Fox Inspection Group

Frame Inspection Report

13802 Arroyo Grande, Cypress, TX 77433
Inspection prepared for: Jorge Galeano
Real Estate Agent: Aaron Greeley - CB&A, Realtors

Before Sheetrocking

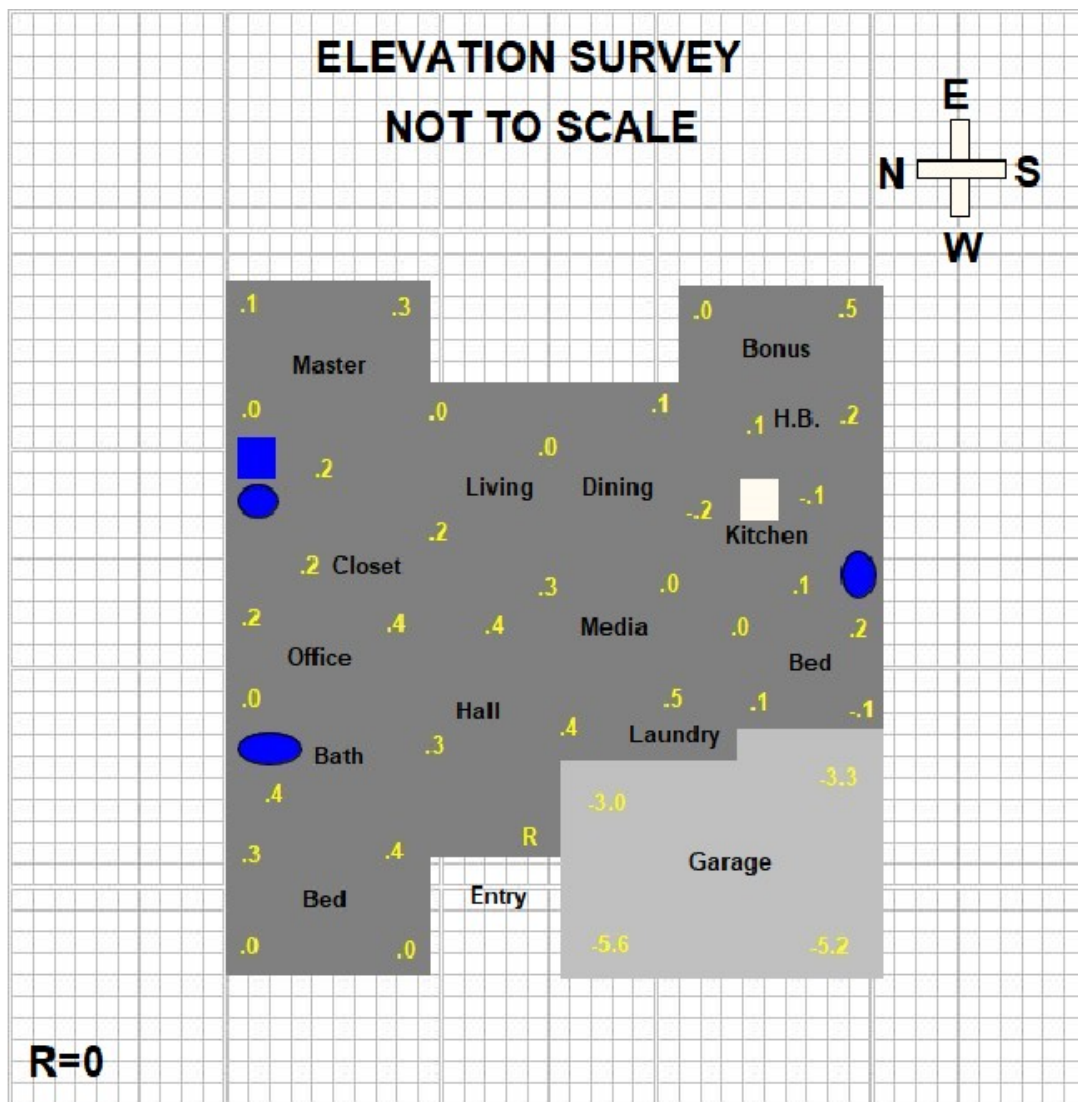
Post tension cable live ends are exposed/ not cut back at all four corners

Post tension cable live ends are exposed/ not cut back at all four corners

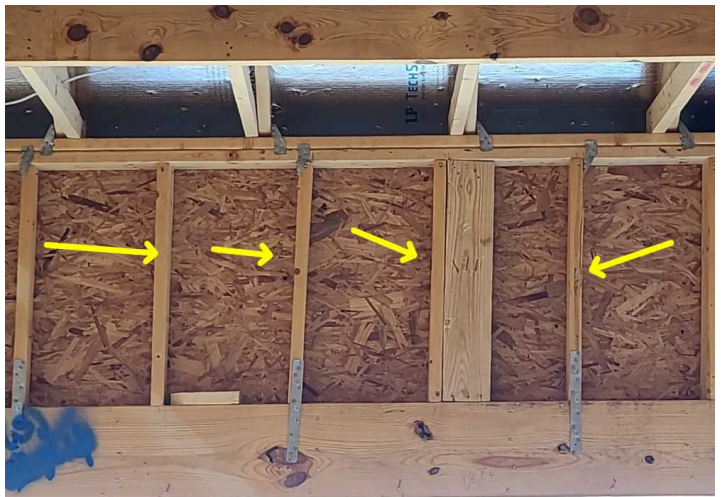
Improperly/ excessively notched framing at South guest bathroom.

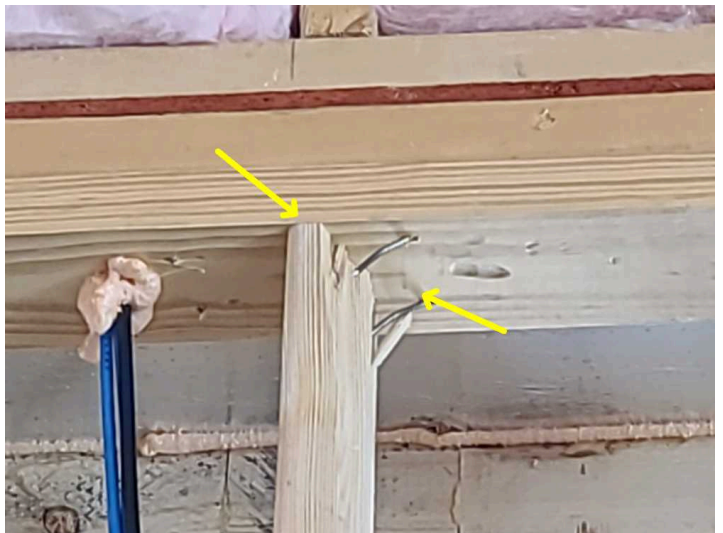
Wall framing not properly attached to foundation, missing a washer, and a nut; garage

Garage wall stud is not flush with sole plate. May cause a bow in sheetrock.

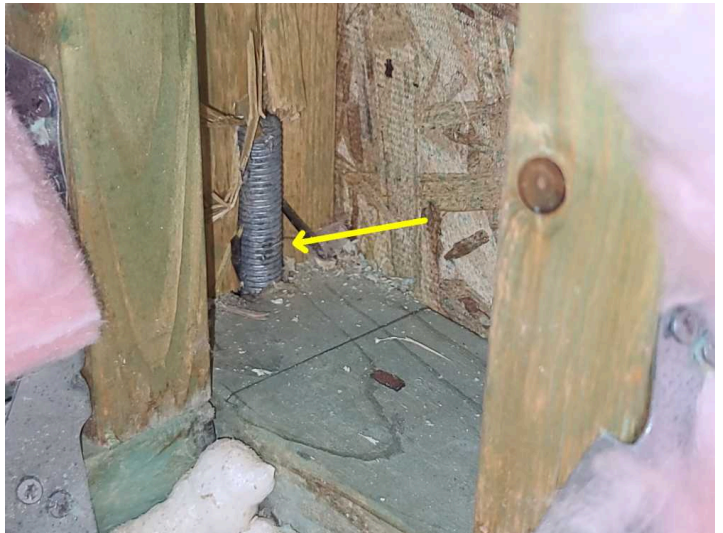
Framing/ stud above fireplace is damaged and are not completely nailed in place properly.

Wall framing not properly attached to foundation, missing a washer, and a nut; Northwest corner/ bedroom

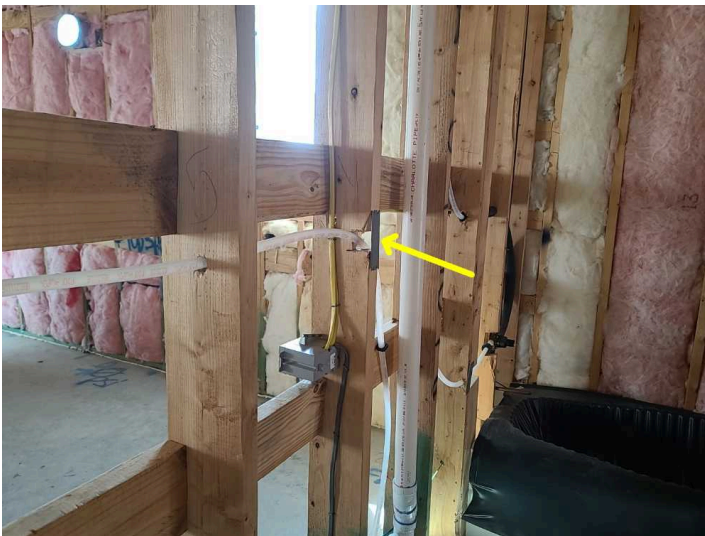
Wall framing not properly attached to foundation, missing a washer, and a nut; Northwest corner/ bedroom

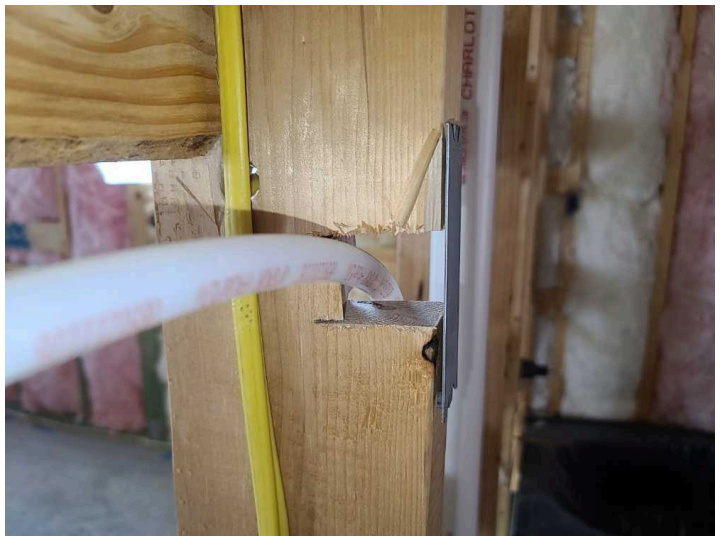
Excessively notched framing at South guest bathroom.

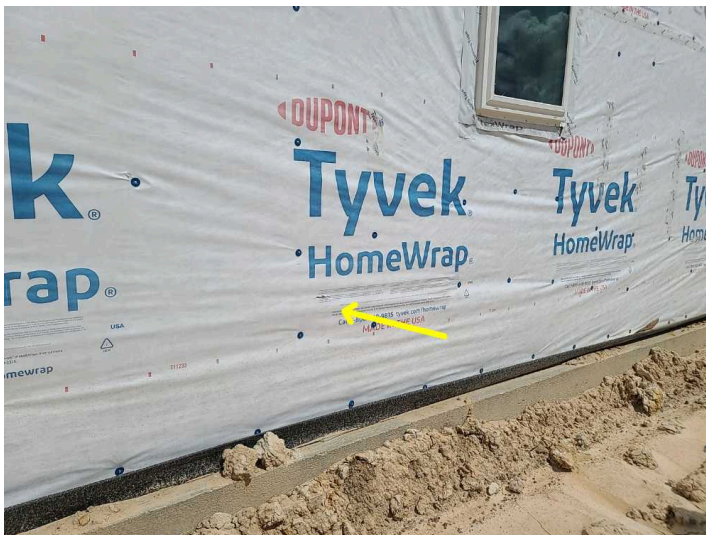
Kitchen cabinet blocking is missing along West wall

Kitchen cabinet blocking is missing along West wall. Additional blocking is needed to properly attach/ support cabinetry.

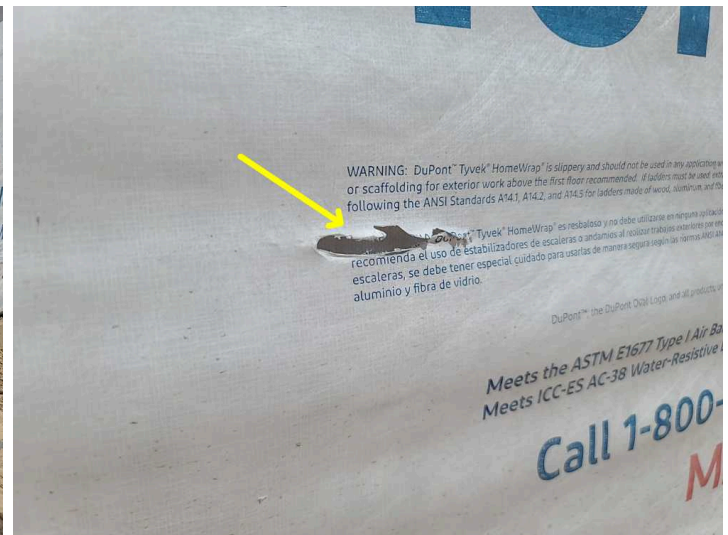
Blocking loose, not square above master bedroom entrance.

Repair holes/tears in house wrap; South exterior.

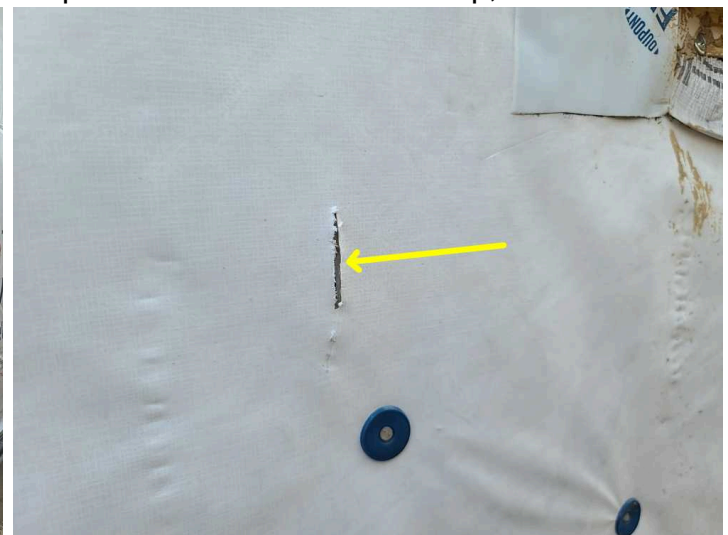
Repair holes/tears in house wrap; South exterior.

Repair holes/tears in house wrap; North exterior.

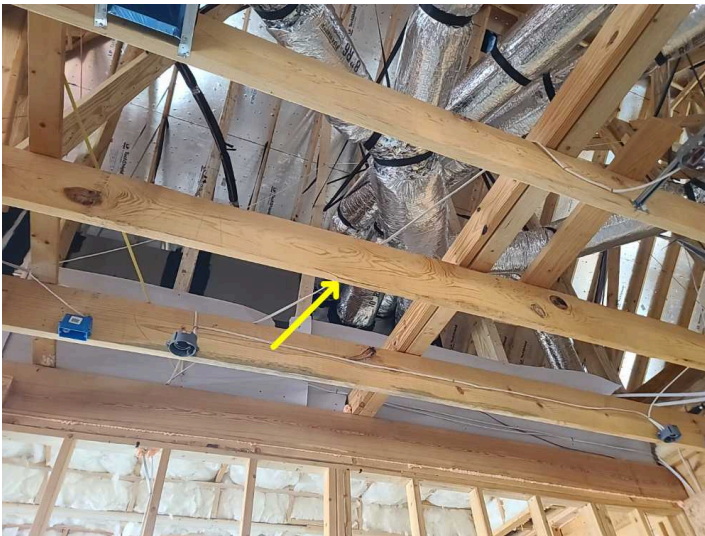
Cracked/ split/ damaged ceiling joist observed at media room ceiling.

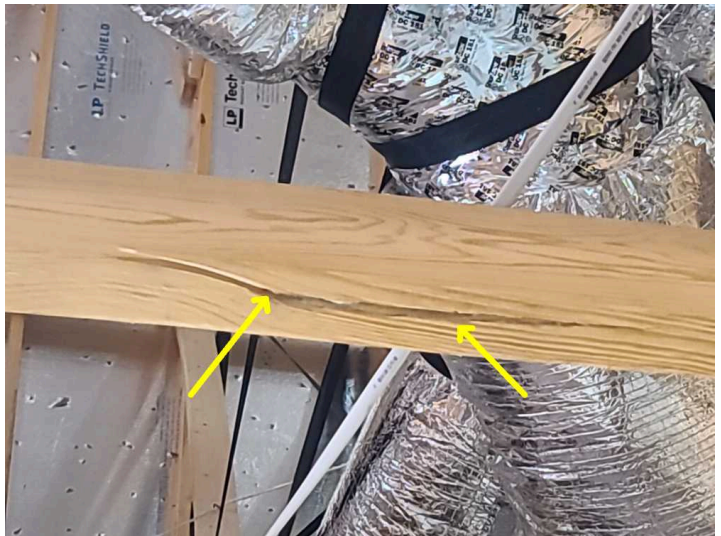
Joist hanger missing nails/ fasteners at the attic access.

Cracked/ split/ damaged ceiling joist observed at media room ceiling.

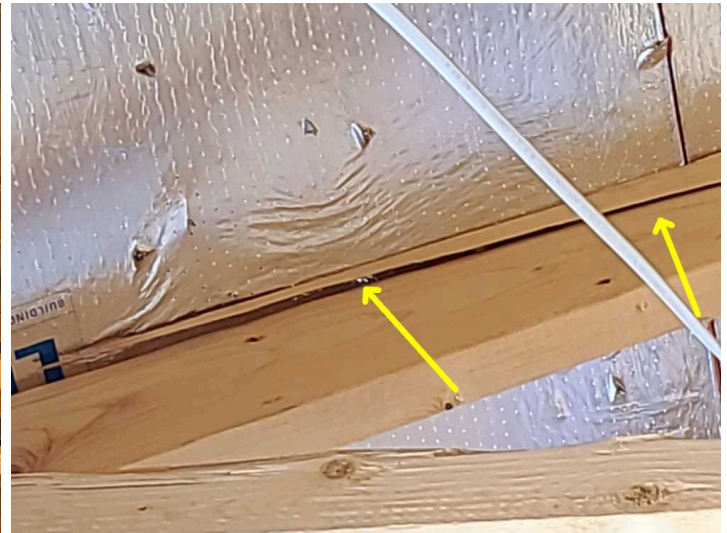
Damaged / cracked / split rafter observed above; guest bedroom.

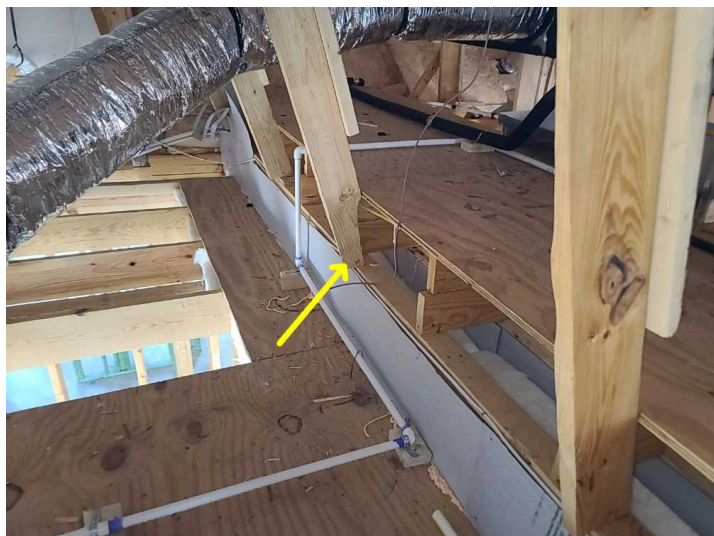
Ends of rafters were observed to be not cut flush with corresponding components; Area that needs repair is above attic access.

Ends of rafters were observed to be not cut flush with corresponding components; Area that needs repair is above attic access.

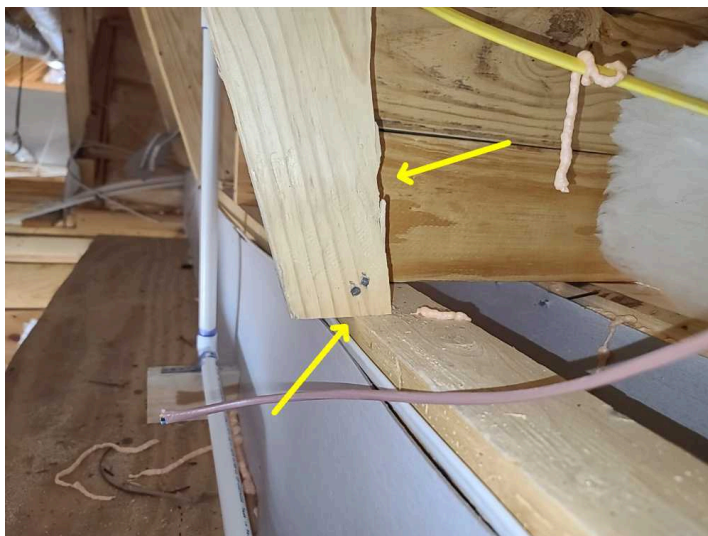
Rafters warped North side of attic above entry hall. Roof decking is not rated for the distance between rafters

Purlin strut is damaged and is not properly bearing on the top plate. Needs repair; near HVAC.

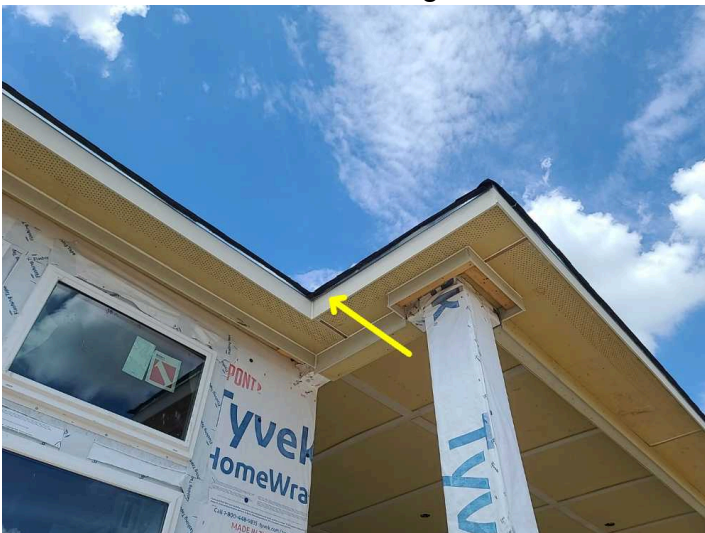
Rubber gasket of drain waste vents have an inverted rubber gasket

Rubber gasket of drain waste vents have an inverted rubber gasket

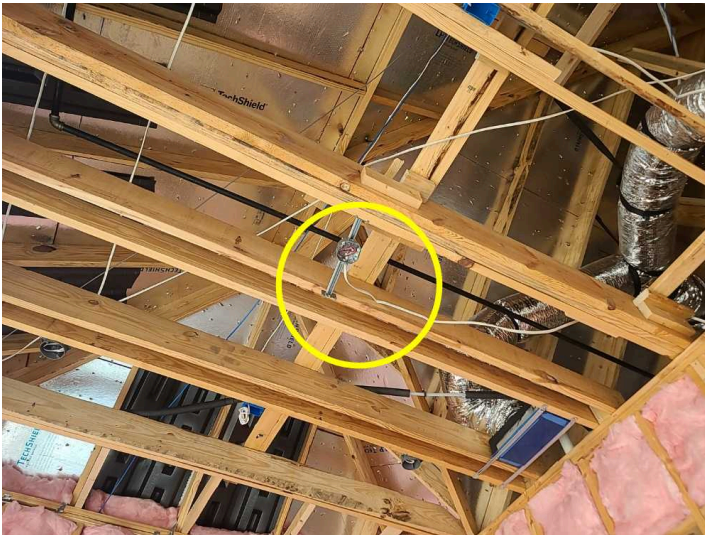
Nail plates missing at office near tub

Nail plates missing at office near tub

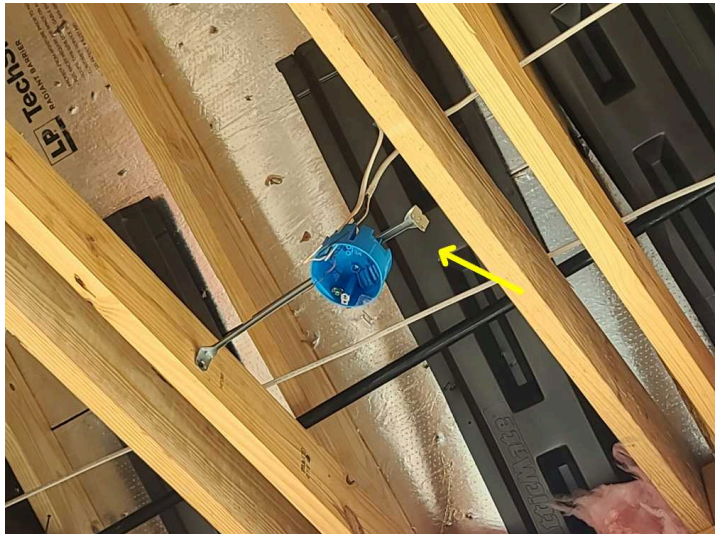
Fixture boxes are not properly secured in place, pulled loose for added framing; bonus/ flex room ceiling.

Electrical wiring is not properly secured in place; bonus/ flex room ceiling

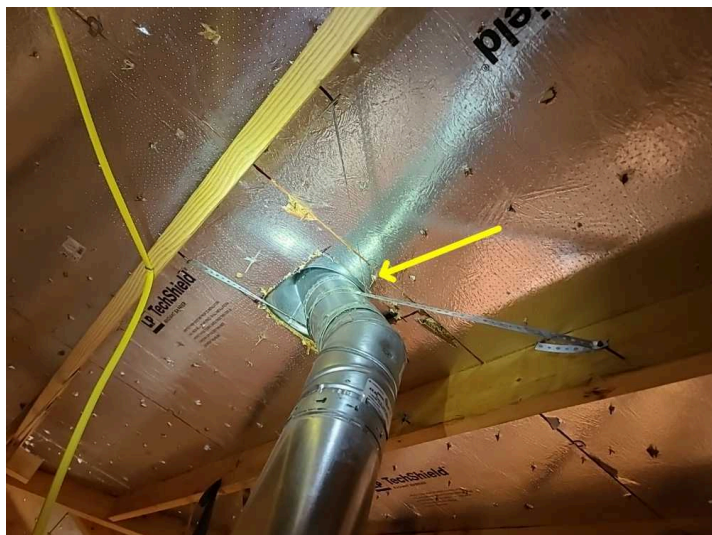
Flex duct excess material in bends; bonus/ flex room.

HVAC supply register boxes are not square with each other due to framing changes. Recommend reinstalling before sheetrock; bonus/ flex room ceiling.

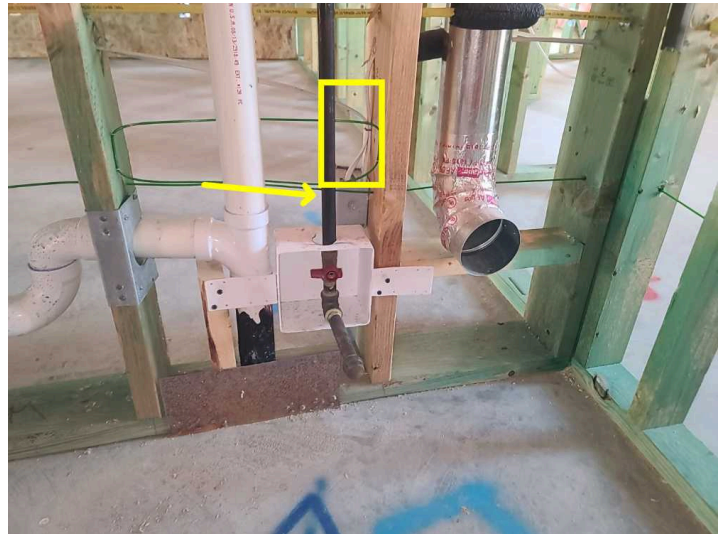
Fiberglass tub securing clips are not properly seated at tub lip; Northwest guest bedroom.

Sink water supply lines and sink drain at laundry room were not present at time of inspection. Should be addressed before sheetrock.

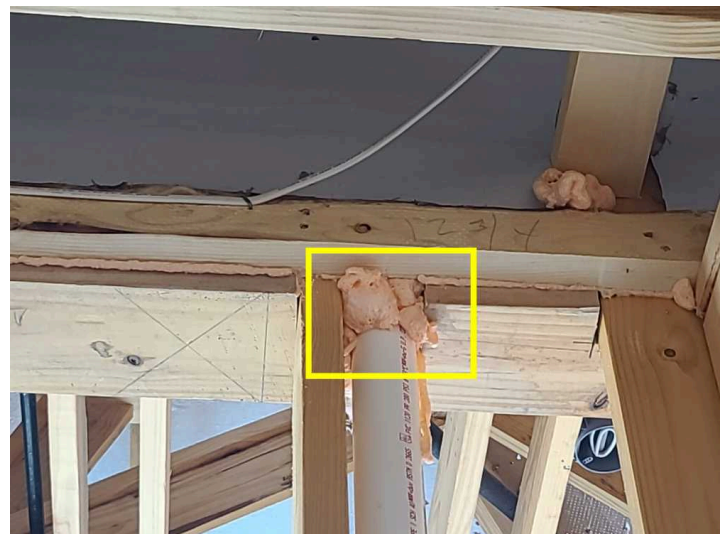
Water supply line not properly secured at; bonus room ceiling

Water supply line not properly secured at; refrigerator area

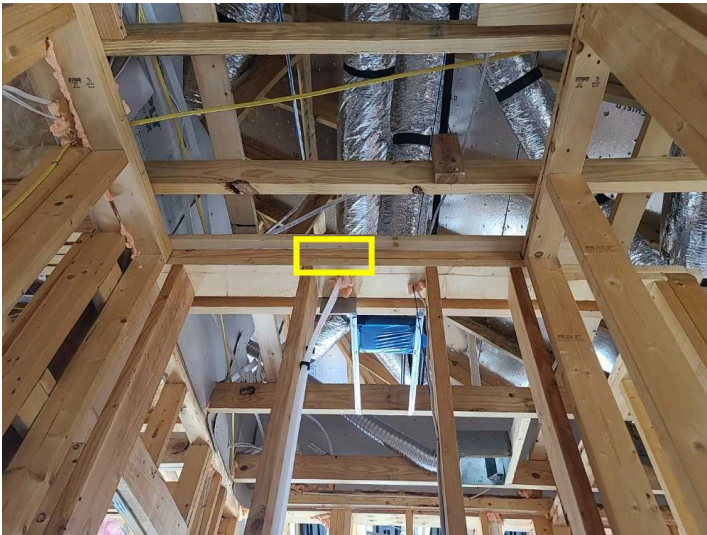
Nail plates missing at half bath

Nail plates missing at refrigerator nook

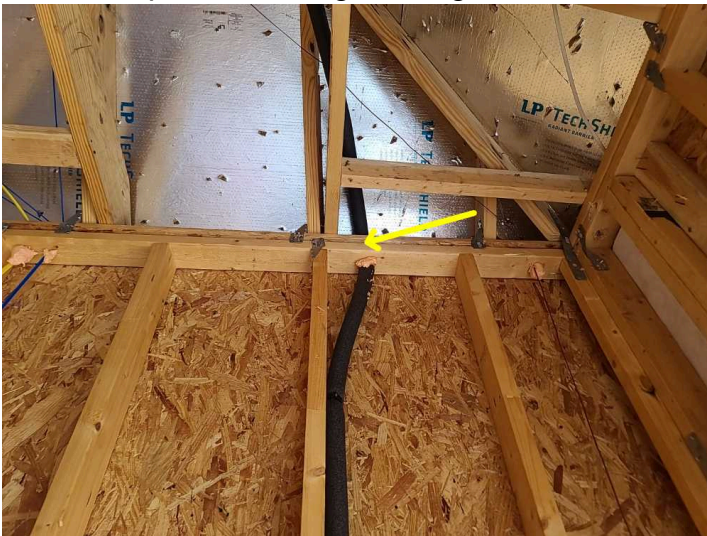
Nail plates missing at refrigerator nook

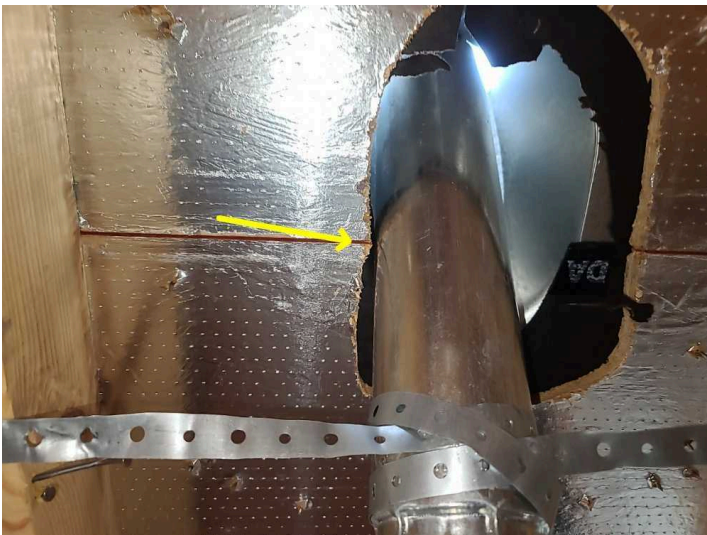
Nail plates missing at garage

Damage observed to the body of the water heater.
Possibility of hidden damage to the unit.

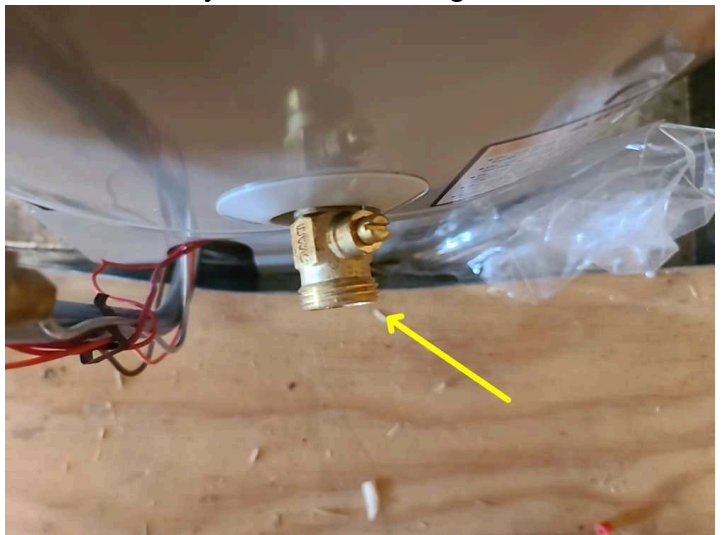
Exhaust vent pipe is in contact with or does not have required minimum 1" clearance from combustible material
